Please find attached RIDA application RPI17/004/BENGAL submitted by Bengal Coal to undertake resource activities within a Strategic Cropping Area for their Dysart East Coal project.

RPI Act assessing agency – Response to application

Figure 2: Tenures to be impacted by proposed activities, and the extent of disturbance of proposed areas on SCL

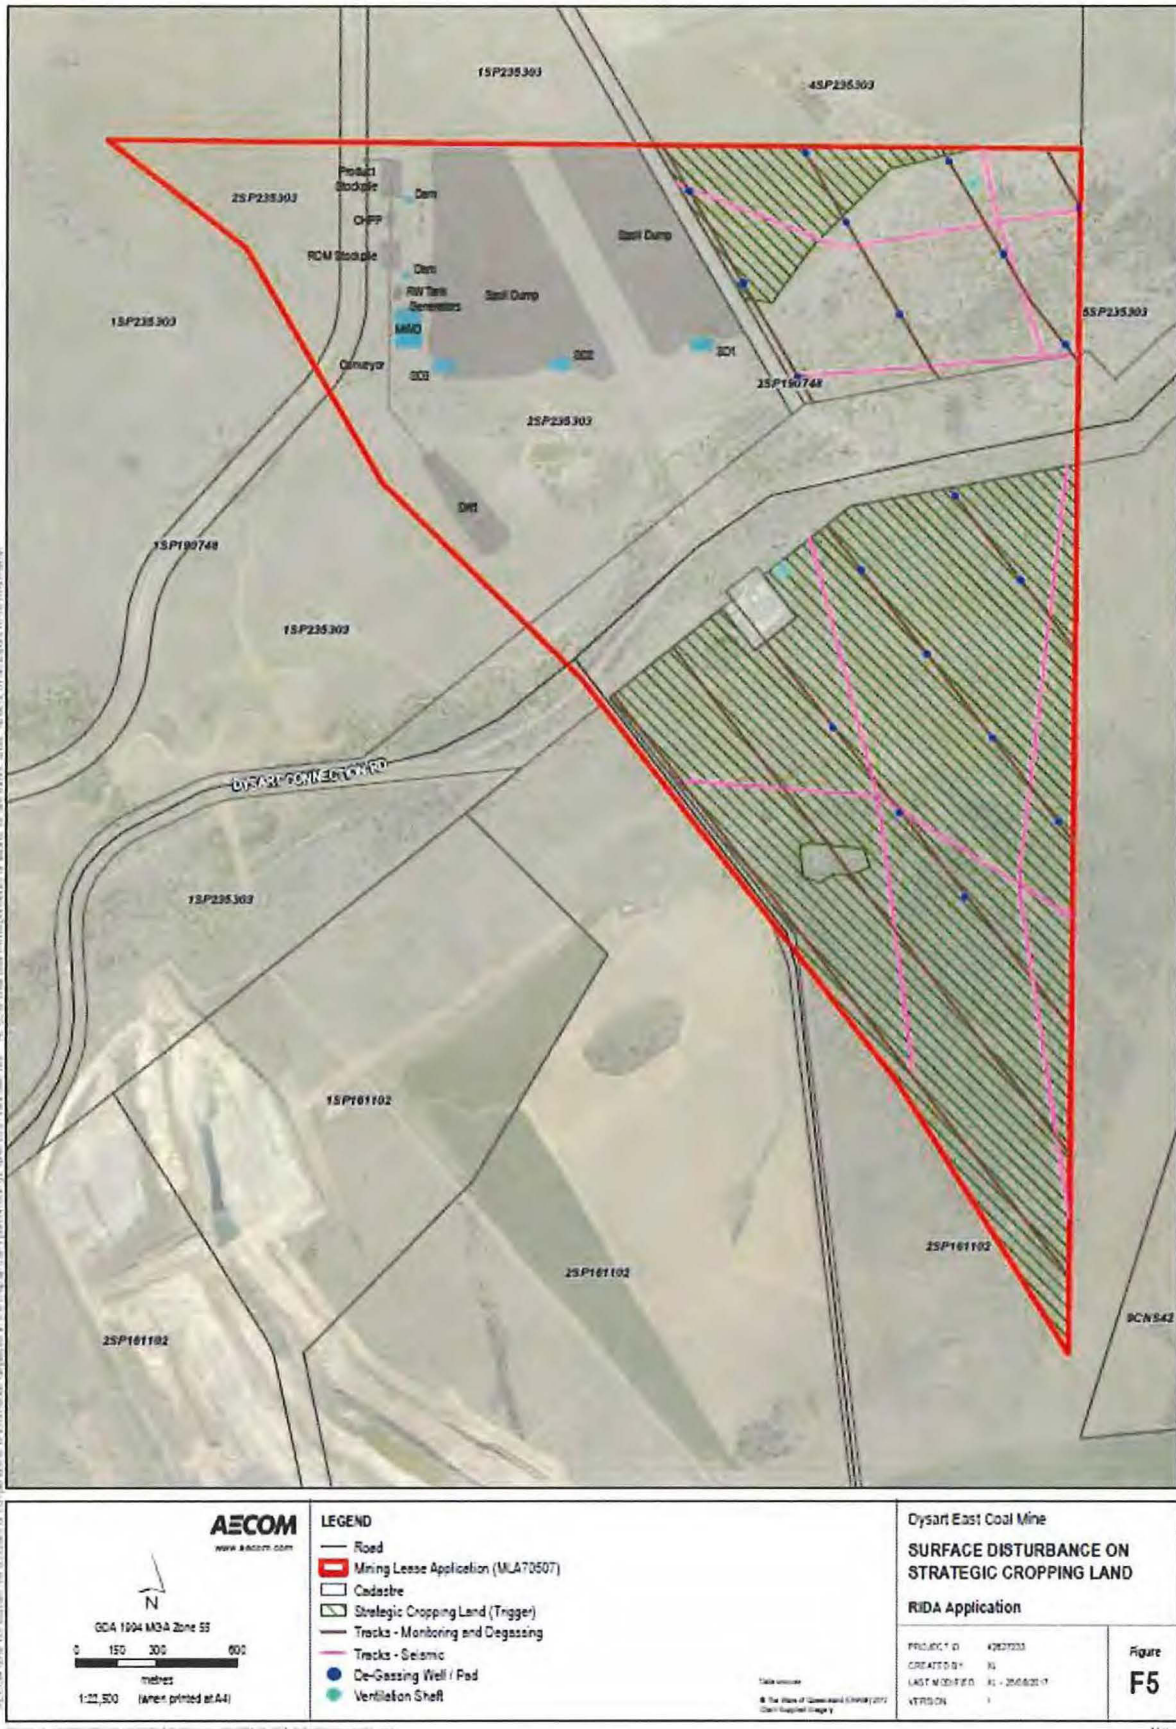
As shown below, 'Figure 2: Tenures to be impacted by proposed activities, and the extent of disturbance of proposed areas on SCL' sets out the permanent impacts on SCA as a result of the proposed resource activities. The total extent of SCA to be impacted 5.48.

Figure 5: Client supplied 'Table 5' from Page 13 of Appendix B ' of Report by SRT on the 18th of February 2014.

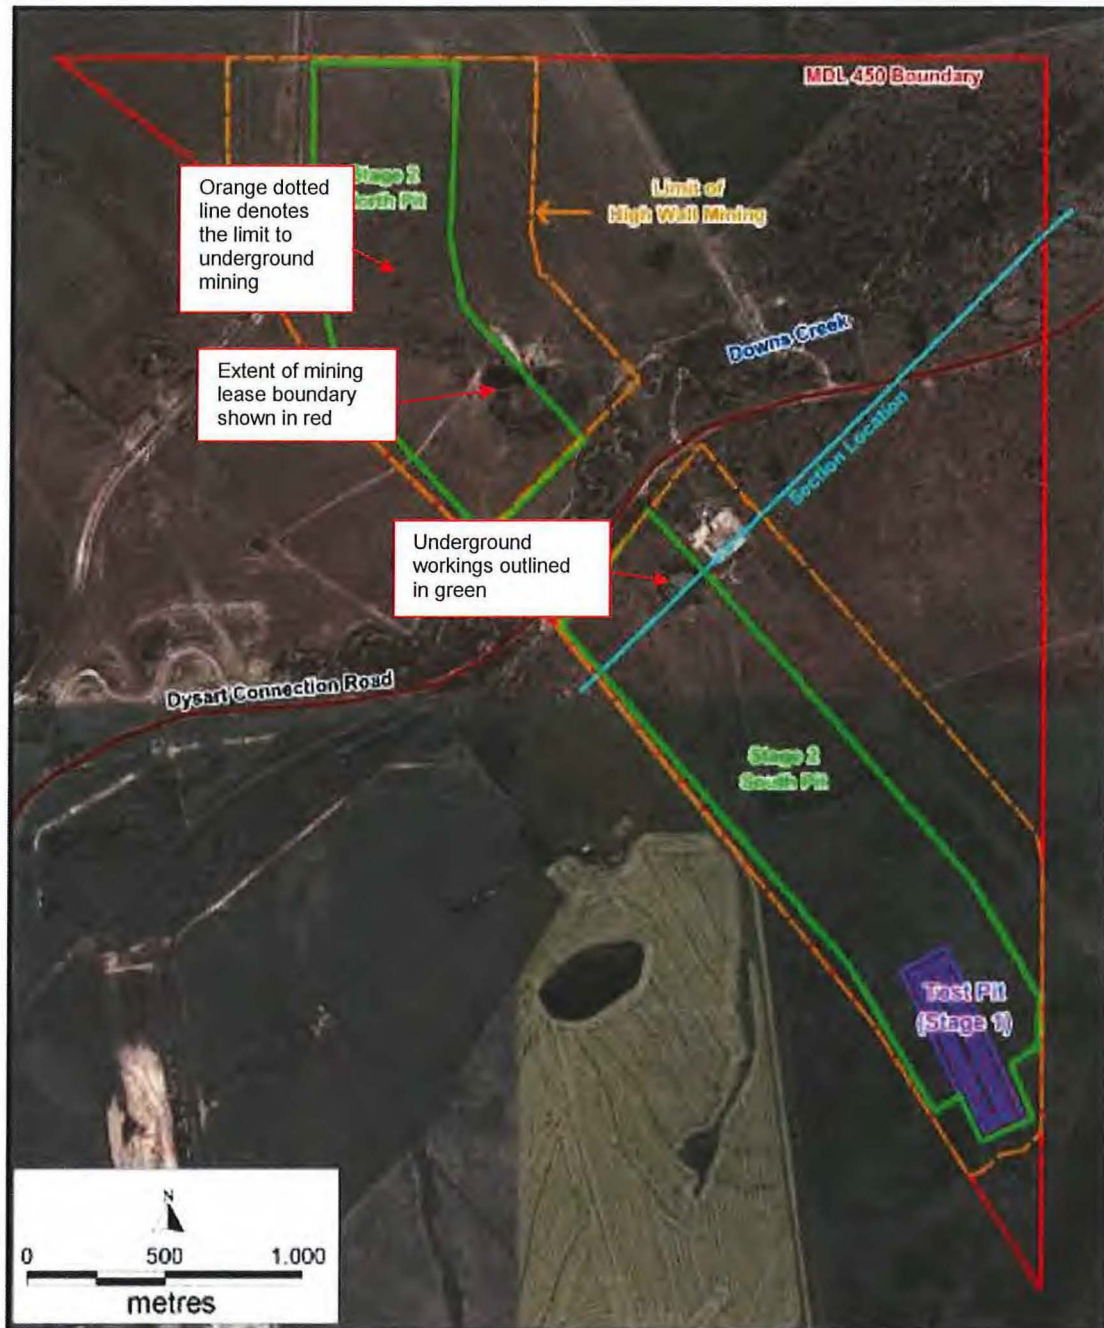
- a. 'For the 11 seams assessed here at a net coal thickness of 15m, resulting in up to 100mm subsidence at 250m, the following tilts would result for varying depths, consistent with Category A impacts.'

Figure 7: Client supplied 'Figure 1' from Page 2 of Appendix B ' of Report by SRT on the 18th of February 2014

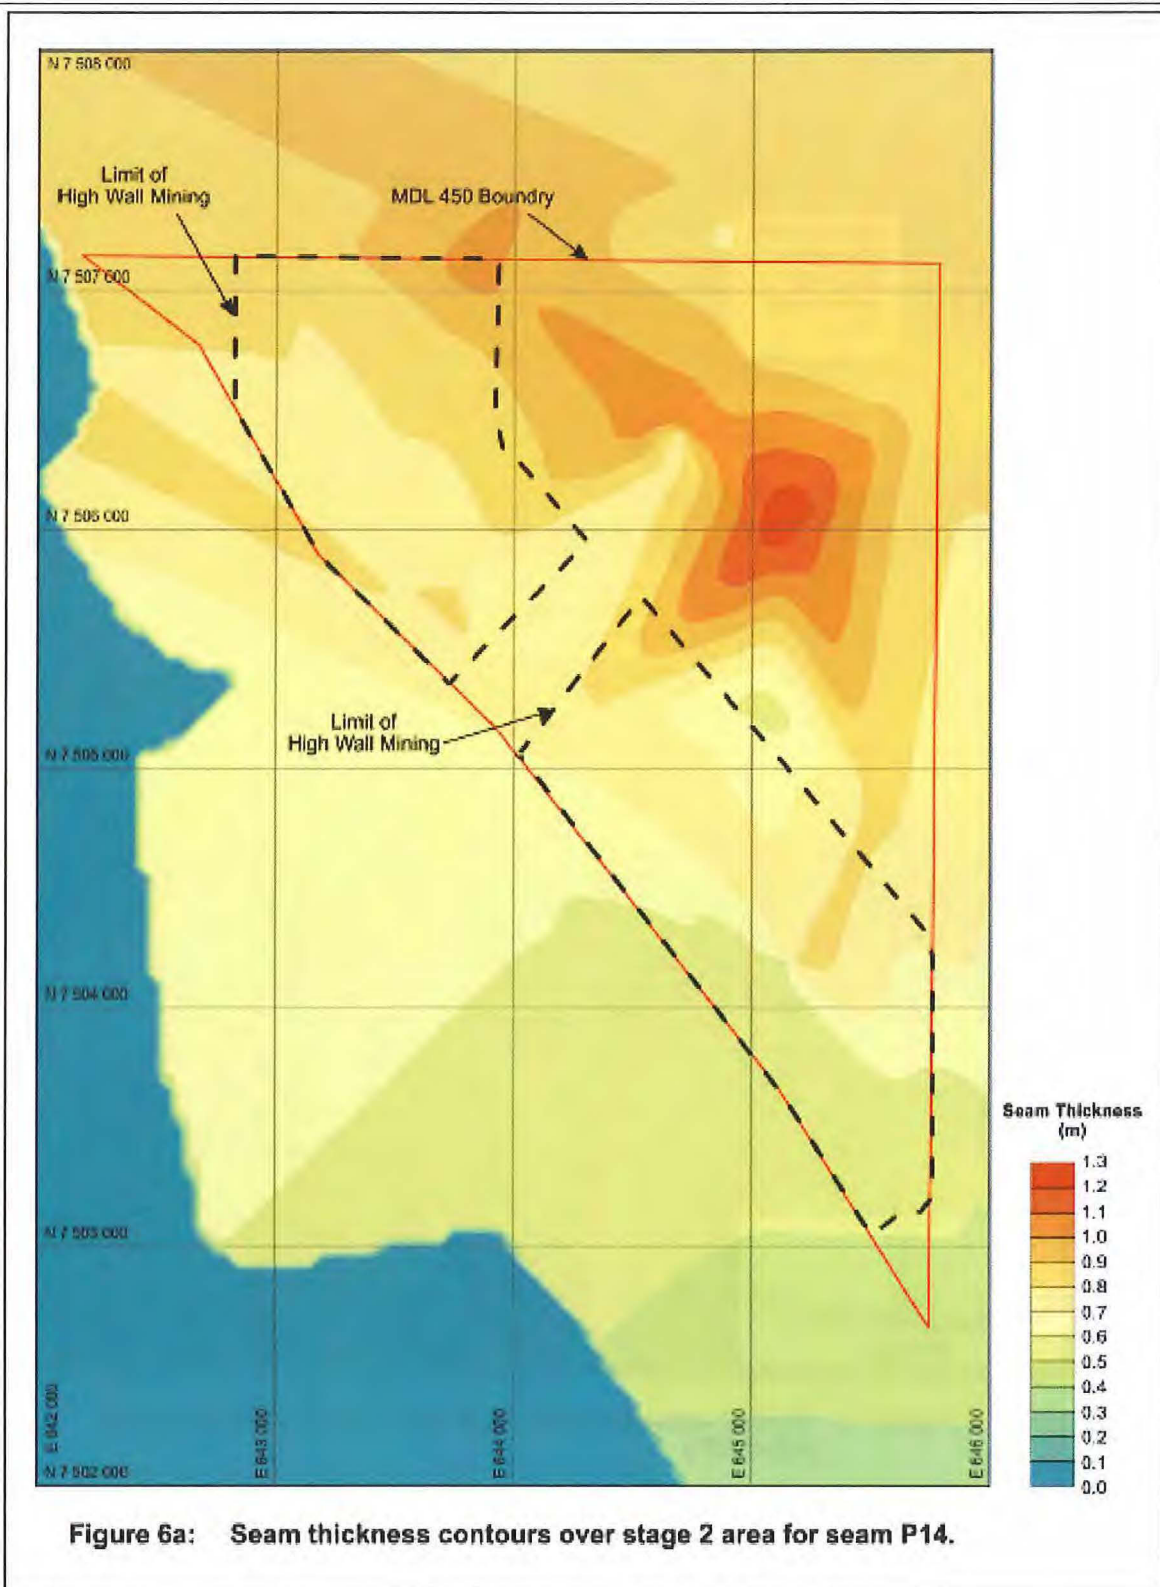
4. Based on the above findings, the applicant demonstrates that the construction and operation footprint of the proposed activity on SCL for the affected area, will be minimised to the greatest extent. The application therefore meets the PS 11(c) for RO2.
